DATE 7/18/89 SUBJECT GRN-07-89-12-07-00 SHEET NO. 1 of 41

THIS ANALYSIS IS BEING CONDUCTED TO ANSWER SPECIFIC QUESTIONS AS PART OF A CONDITIONAL CONCURRENCE AGREEMENT BETWEEN THE DOE AND NRC ON THE GREEN RIVER REMEDIAL ACTION IN UTAH. THE FOLLOWING ARE THE SPECIFIC AGREEMENT ITEMS (NRC, 1989):

ADDITIONAL INFORMATION AND JUSTIFICATION NEEDED IN GREEN RIVER FINAL REMEDIAL ACTION PLAN

MOISTURE CONTENT/DENSITY TEST LOCATIONS

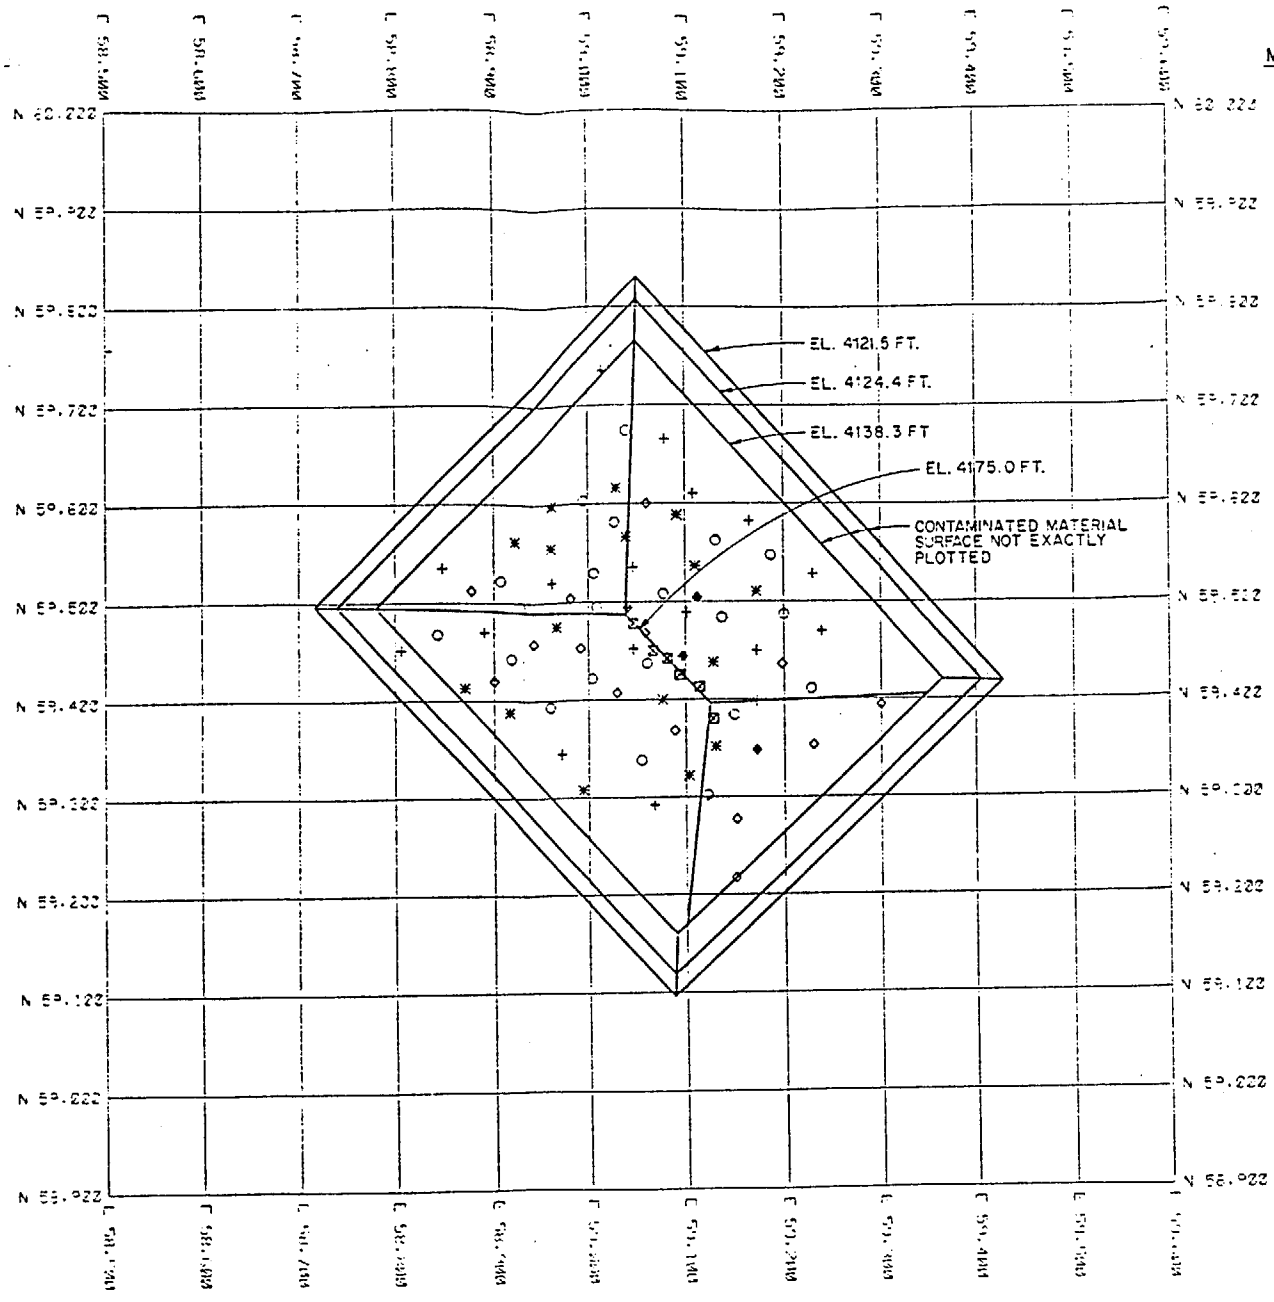
- **Information on all density and moisture content tests performed to verify the placement density and moisture contents of the contaminated materials placed in the disposal cell. The location of the tests should be shown on a plan of the cell along with the elevation of the test location. This is the areal and vertical control information for the test locations.**

Dry density, percentage compaction, moisture content and moisture content relative to optimum moisture content of all density determinations performed on contaminated materials are presented in Tables 3A and 3B. Coordinates and elevations of the compaction determinations are presented in Tables 4A and 4B and plotted on Figure 1. Based on the scatter of test locations on Figure 1, it
